CITY OF MADISON
CITY ENGINEERING DIVISION
DEPARTMENT OF PUBLIC WORKS
PLAN OF PROPOSED IMPROVEMENT

3575 UNIVERSITY AVENUE

CITY PROJECT NO. 15902

REVISION 1 - 12/15/2025
SHEETS REPLACED: P1,U1,U2,USCH,X1

15902	MADISON, WI	9676	U-1
CONTRACT NO:			
15902			
U-1			
M:\DESIGN\Projects\15902\CAD\Sewers\15902SWR-PipeNetwork.dwg			
UTILITIES PLAN & PROFILE			
3575 UNIVERSITY AVENUE			
15902			
U-1

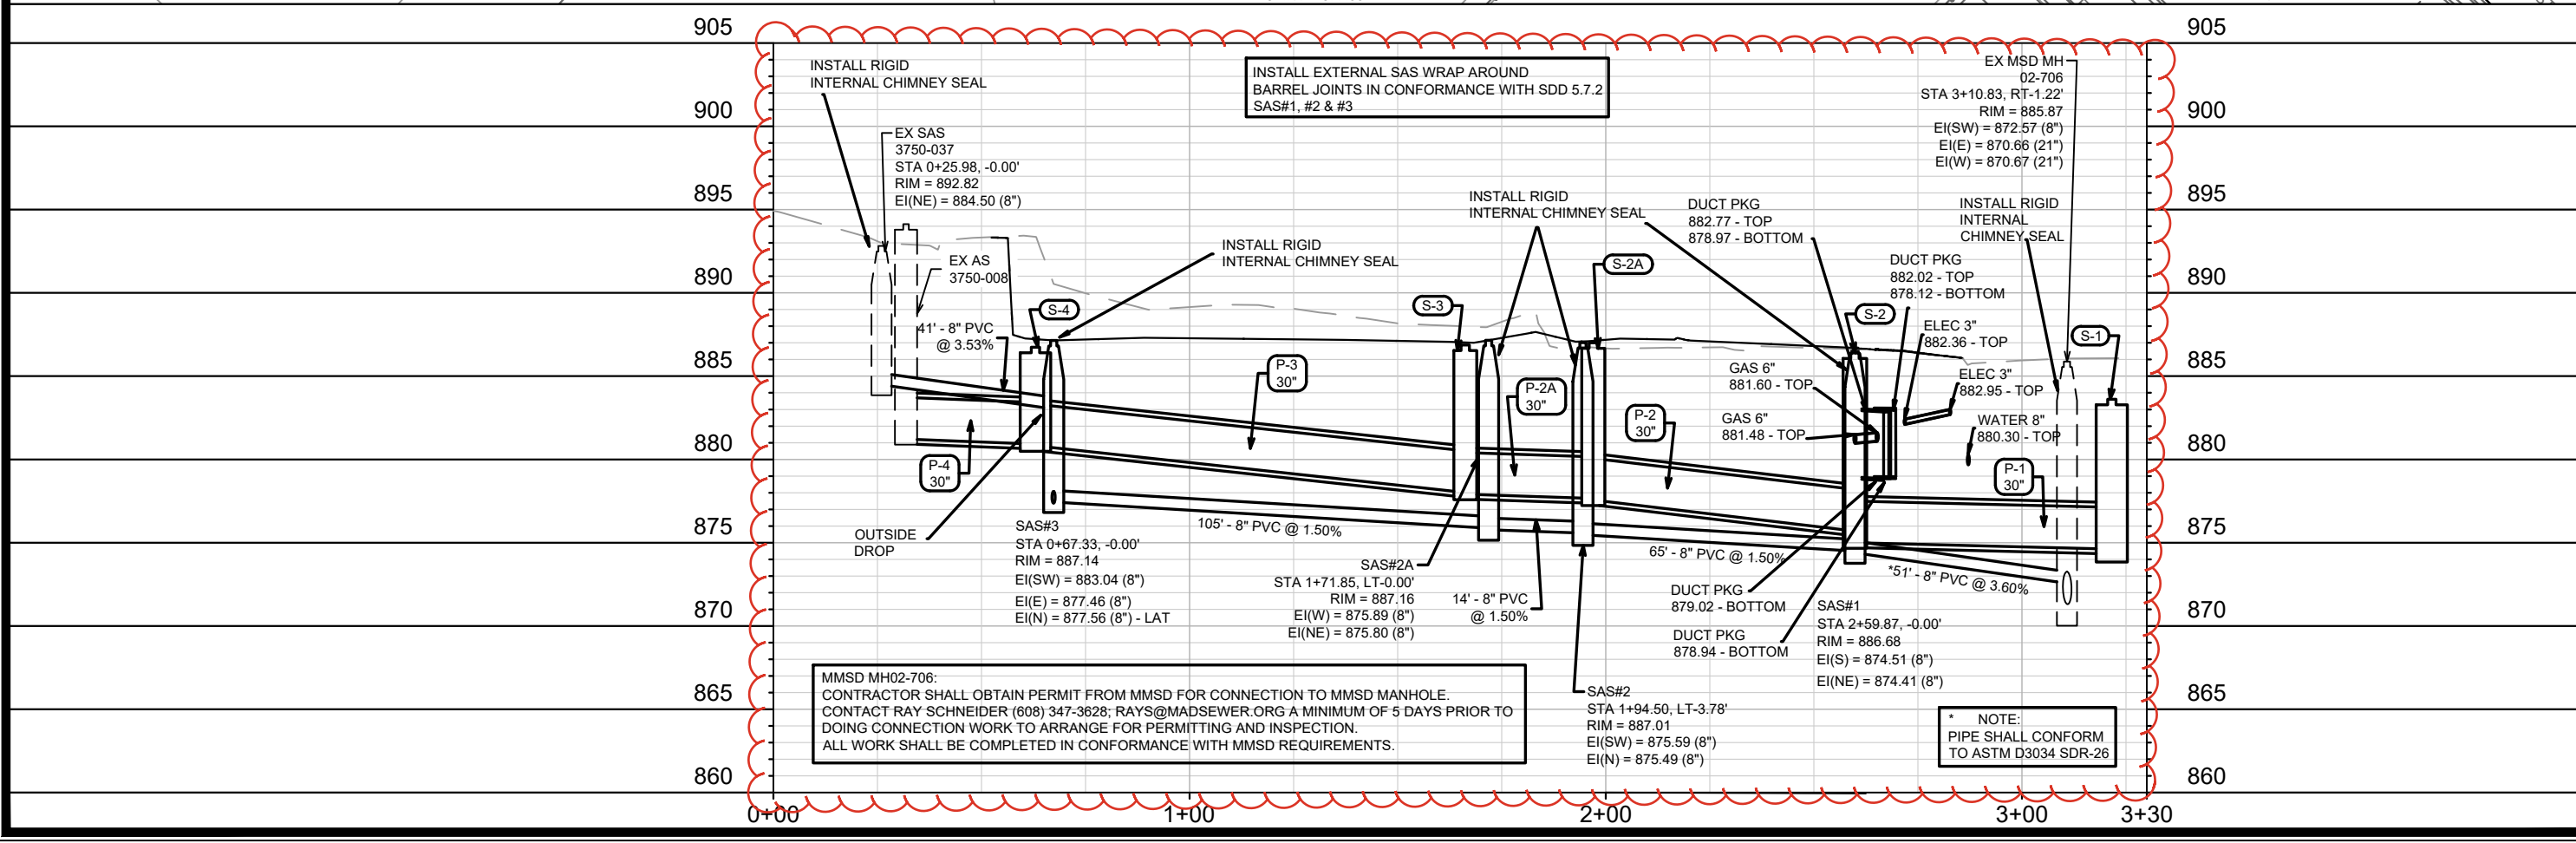
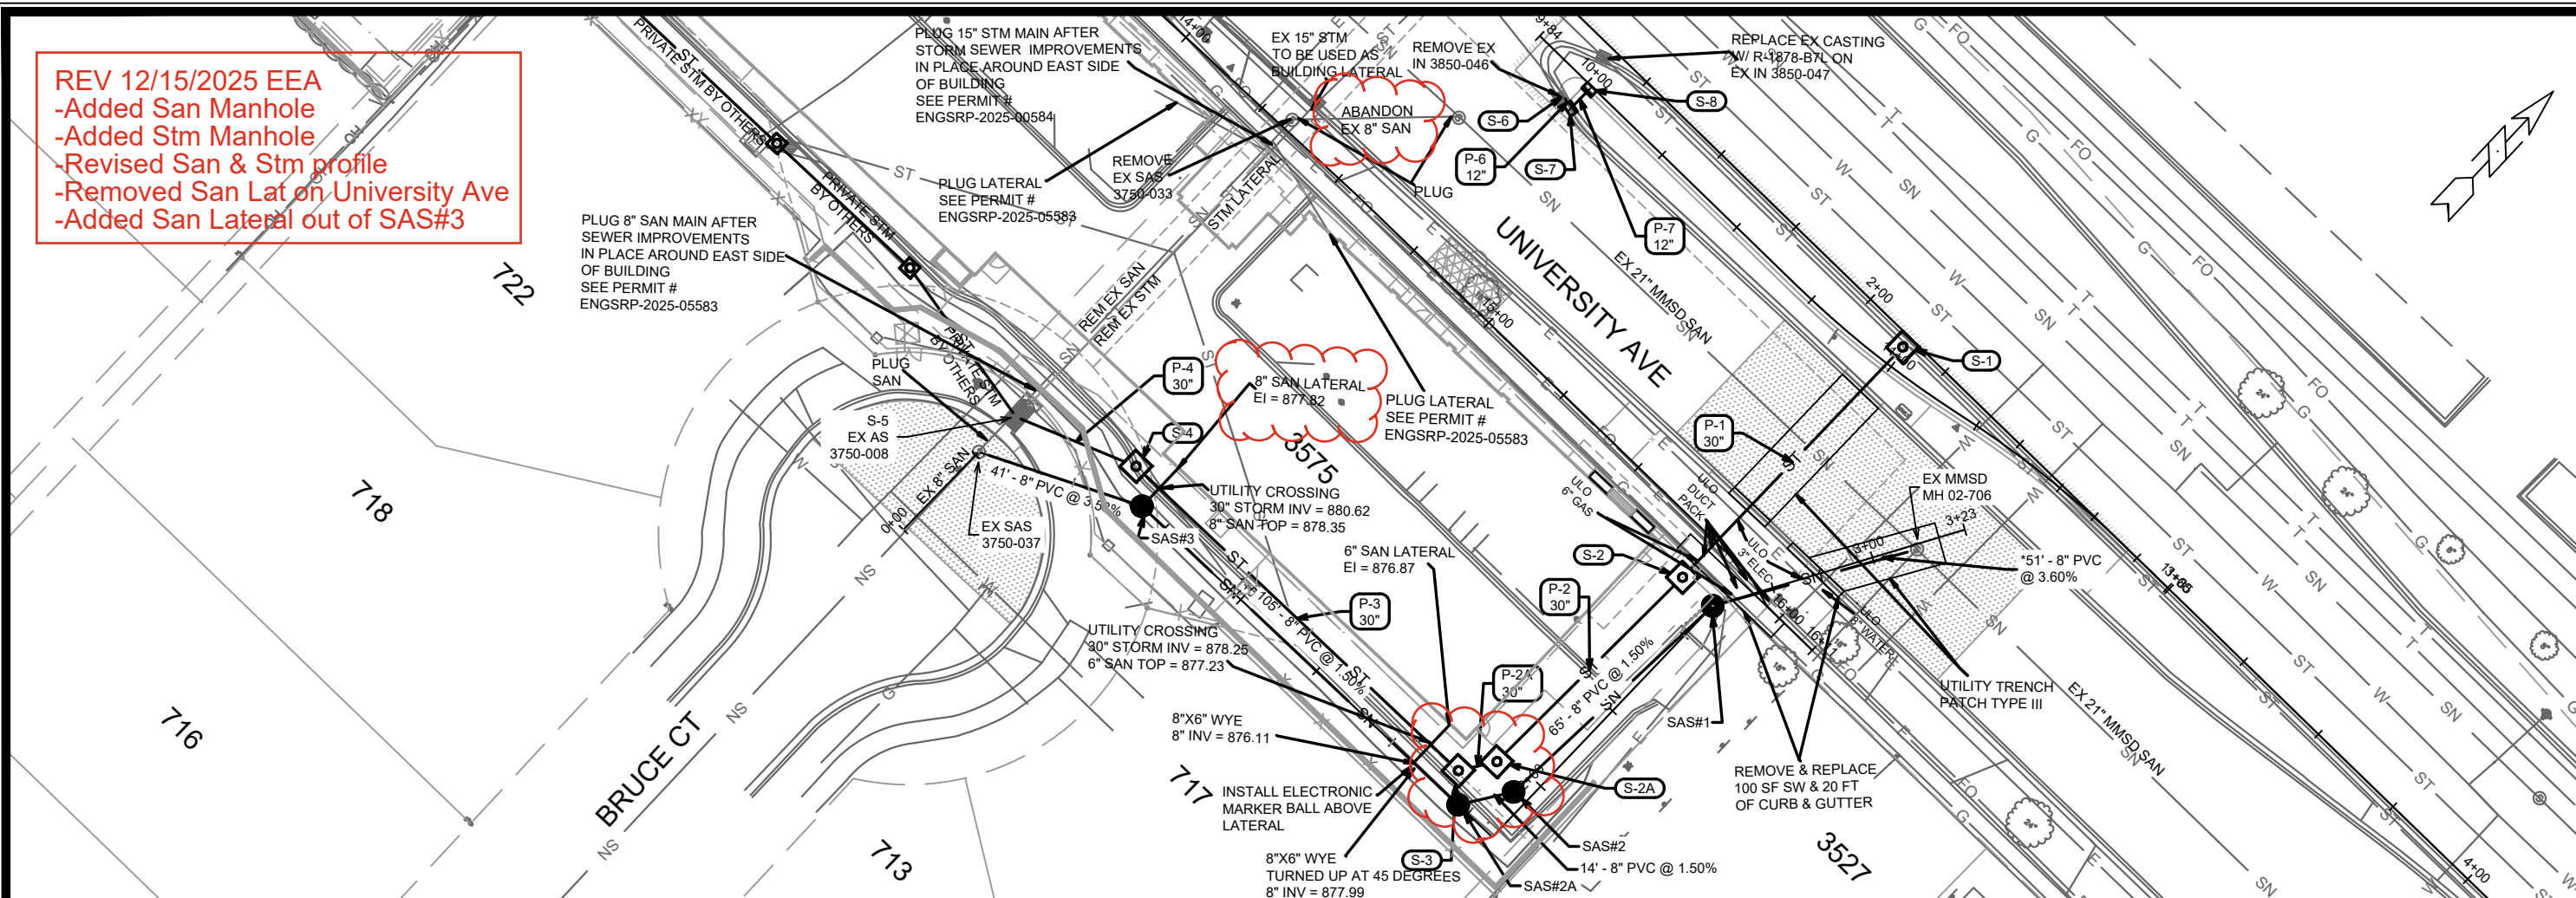
REV 12/15/2025 EEA
-Added San Manhole
-Added Stm Manhole
-Revised San & Stm profile
-Removed San Lat on University Ave
-Added San Lateral out of SAS#3

15902
MADISON, WI
CROSS SECTIONS - MEADOW LANE & UNIVERSITY AVENUE
3575 UNIVERSITY AVENUE
CONTRACT NO: 9676
M:\DESIGN\Projects\15902\CAD\Streets\15902EN-Xsections.dwg

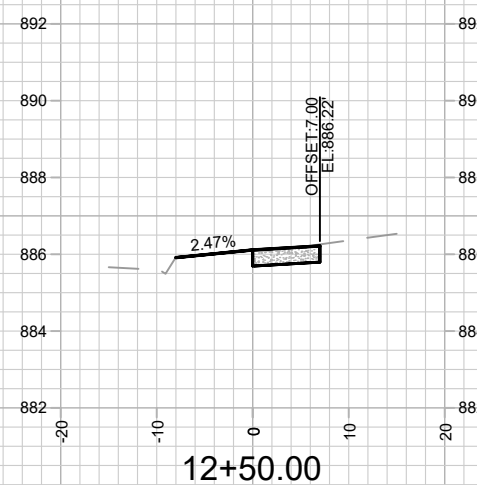
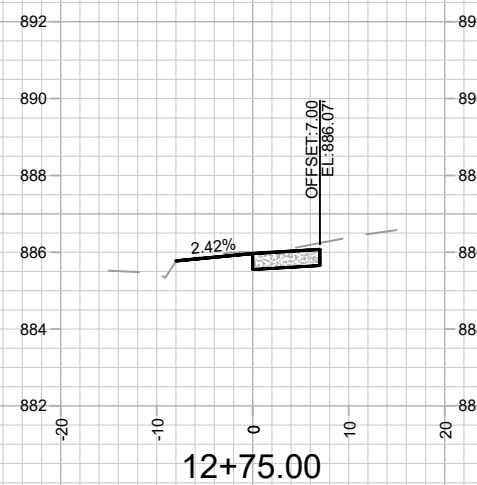
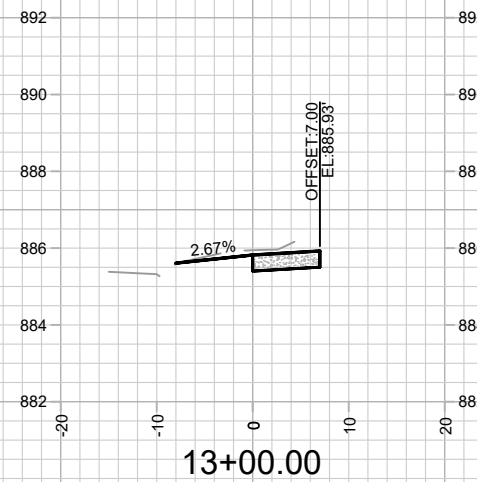
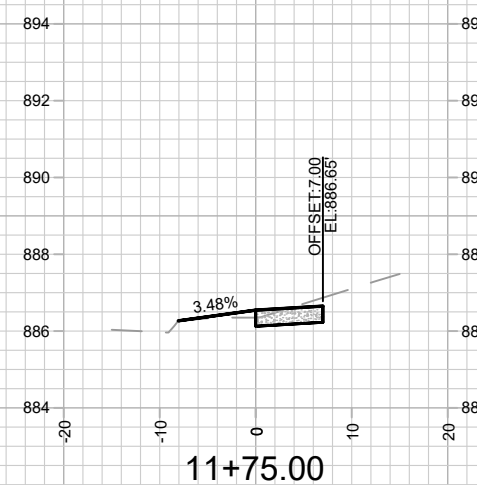
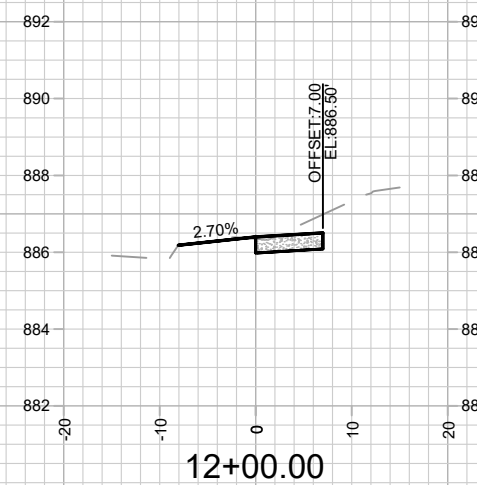
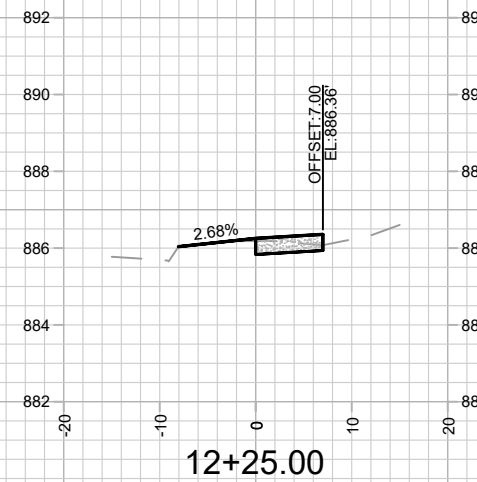
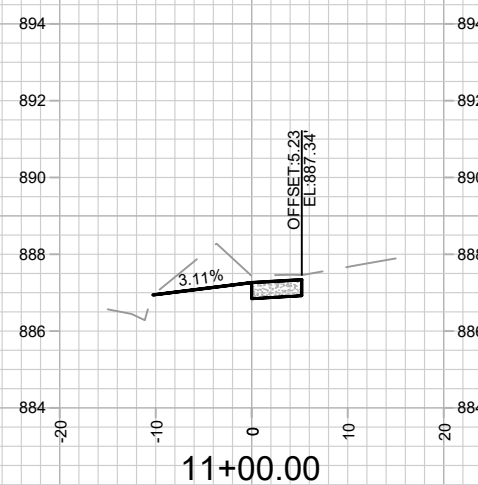
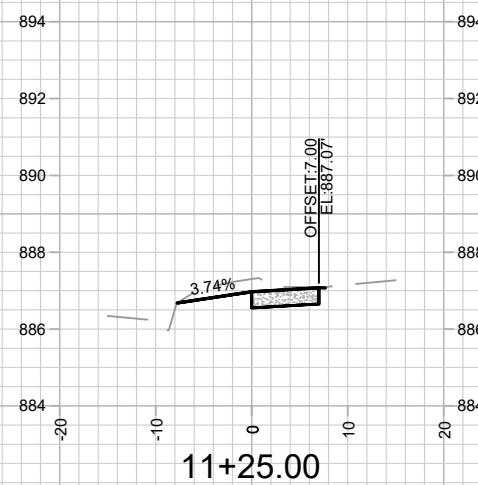
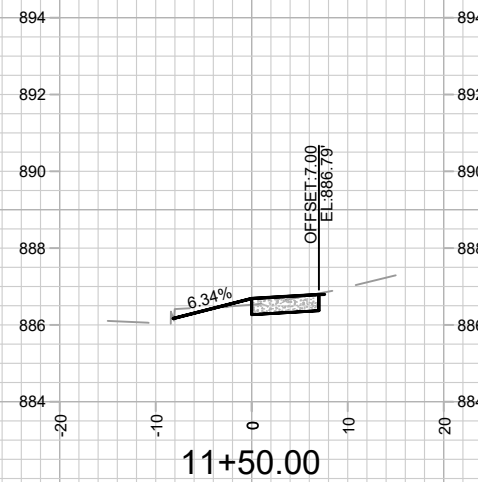
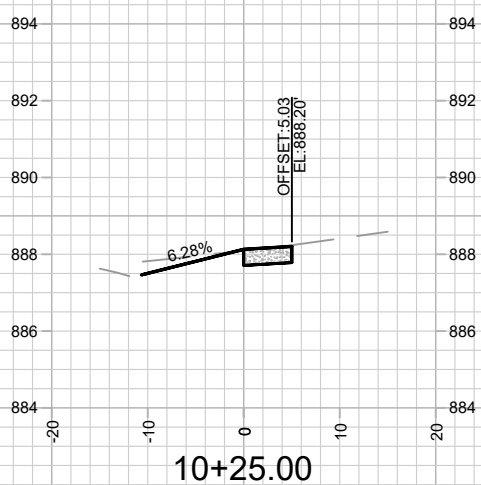
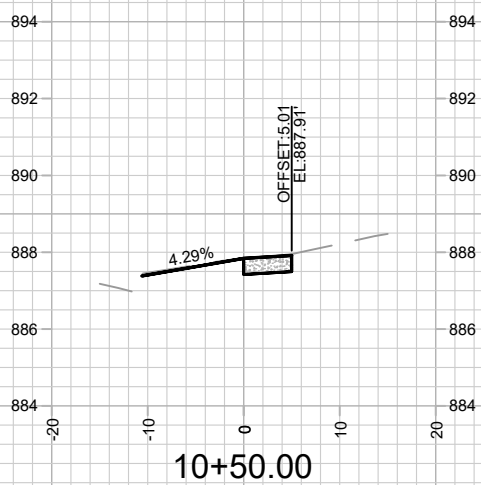
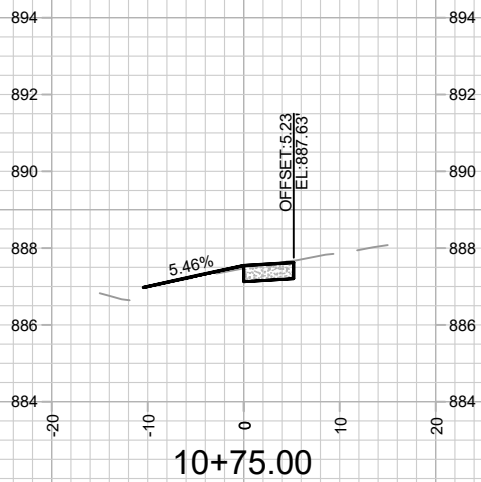
12/15/2025 NGV REV 1:
UPDATE ON SIDEWALK IMPROVEMENTS
GRADES
